## Technical change to Y-distributor (1881710000 - SAI-Y-5S M12/M12 2BO)

the Y-distributor **1881710000** - SAI-Y-5S M12/M12 2BO will be changed.

Preexisting design	New design

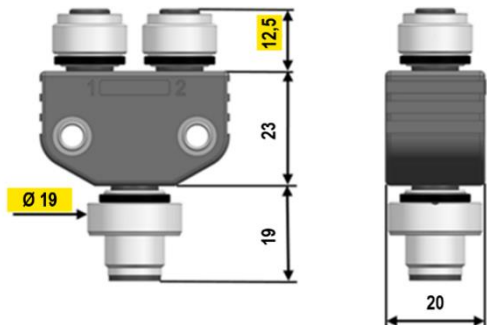
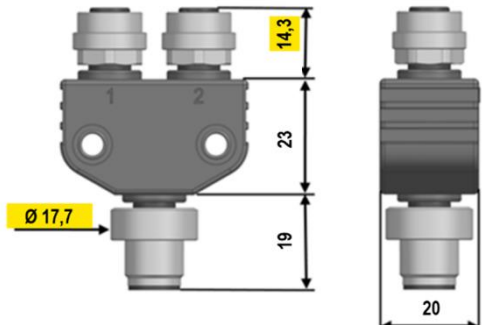
Until now, a lead-containing material was used for the threaded rings of the affected article. As part of the changeover, these will be converted to a lead-free material so that the products comply with the RoHS Directive without exception 6c. The change will result in deviations in the dimensions of the existing article. All other technical specifications remain identical.

<p><b>Note:</b> the two pins for ensuring the distance during assembly are not shown, <b>but remain in the new design with the same dimensions!</b></p>
